October 11, 1985

RE: Review of Abatement Plans, Notice of Violation N85-8-13-2,
Price River Coal Company, Price River Complex, Hardscrabble
Canyon, ACT/007/004, #3 and #7, Carbon County, Utah

RIP-RAP GRADATION CURVE - UNDISTURBED
DRAINAGE ADJACENT TO PONDS 009
PRICE RIVER COAL CO. - HANDSCRABBLE

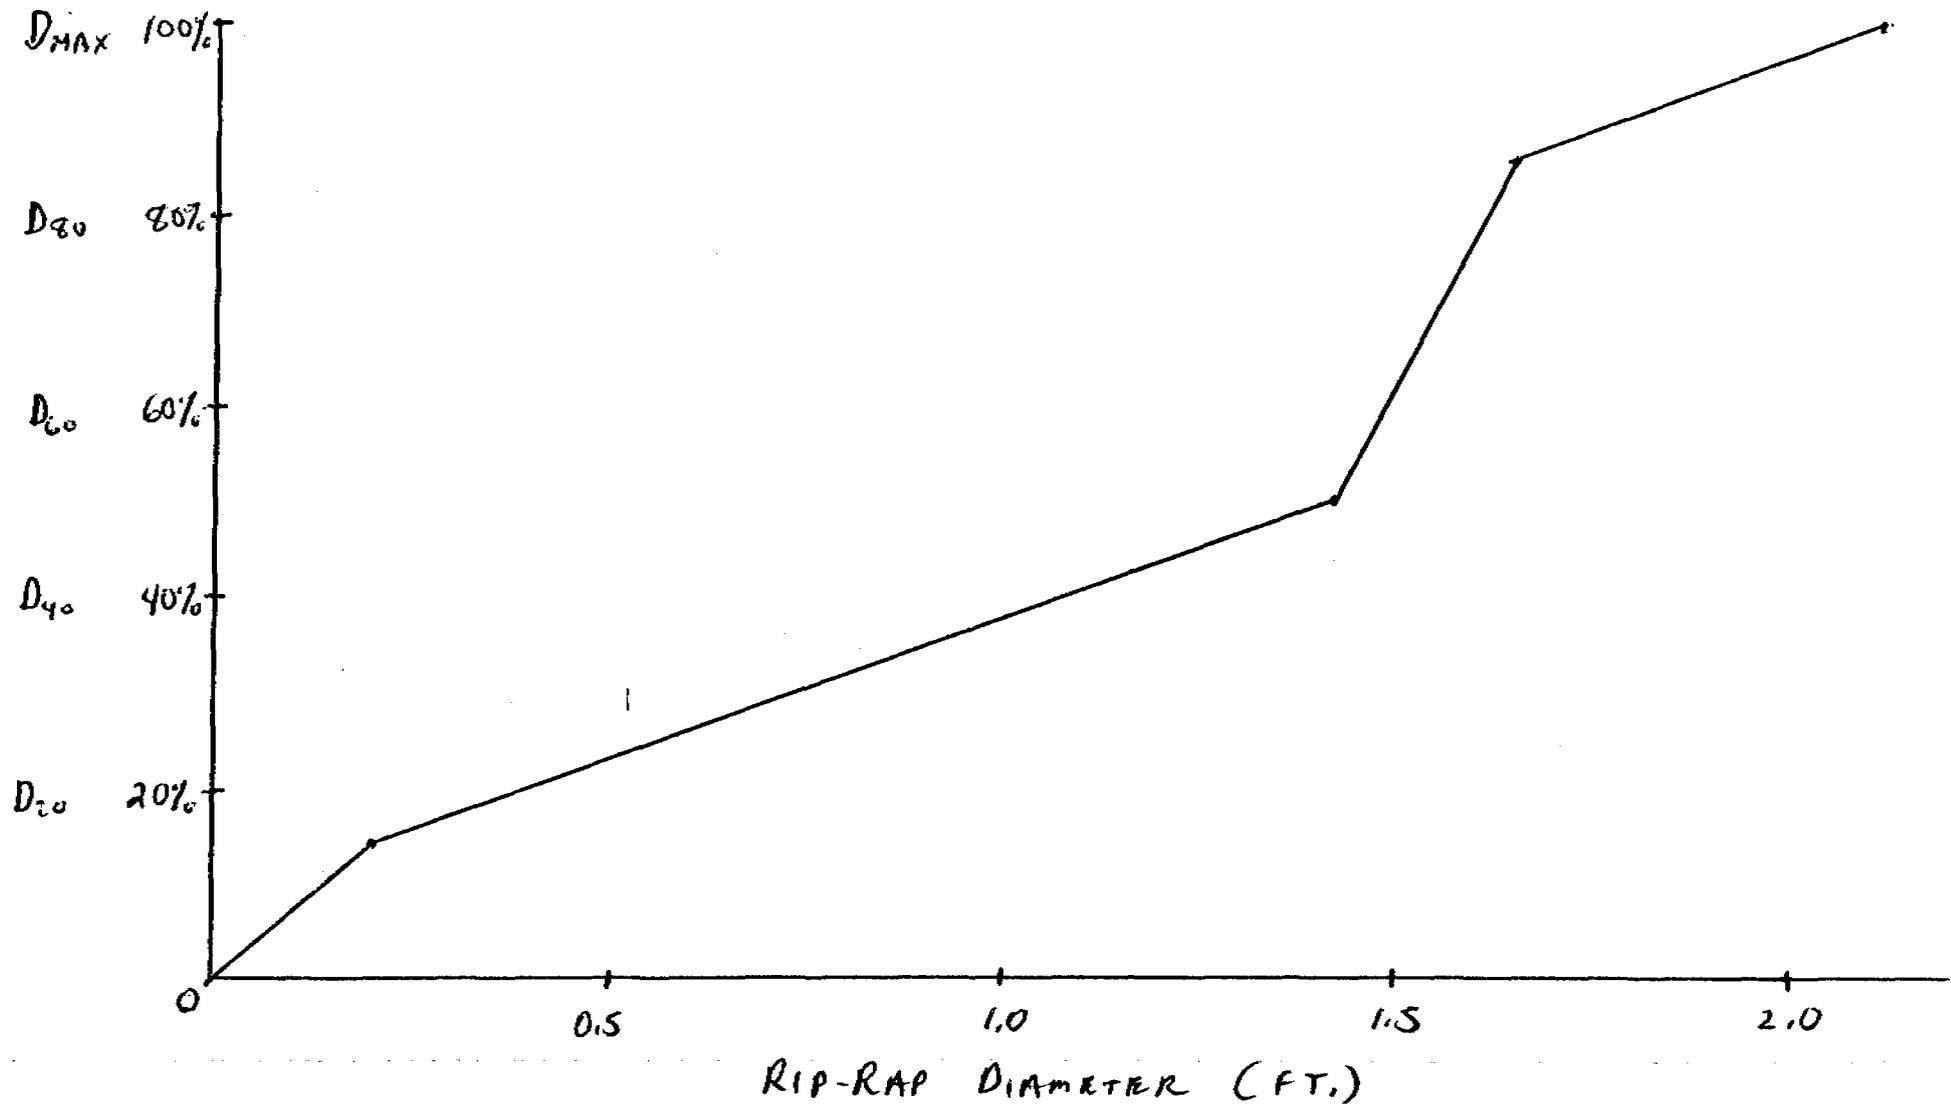
As discussed in a field visit conducted by Division hydrologists Dave Hooper, Jim Fricke and Dave Wham, October 9, 1985, a channel armoring plan was developed for the undisturbed drainage adjacent to Ponds 009. An enclosed map delineates those portions of the ephemeral channel which are to be riprapped and shotcreted. The inner channel sideslope (pond outslope) and channel bottom shall be riprapped using the enclosed gradation curve. In order to prevent riprap failure and piping, it is critical that the riprap material be angular in shape and placed in the graded configuration. Only the pond outslope need be shotcreted according to plan. It is suggested that four inches x four inches remesh be used and be sufficiently anchored to the outslope using fence posts, roof bolts or similar material.
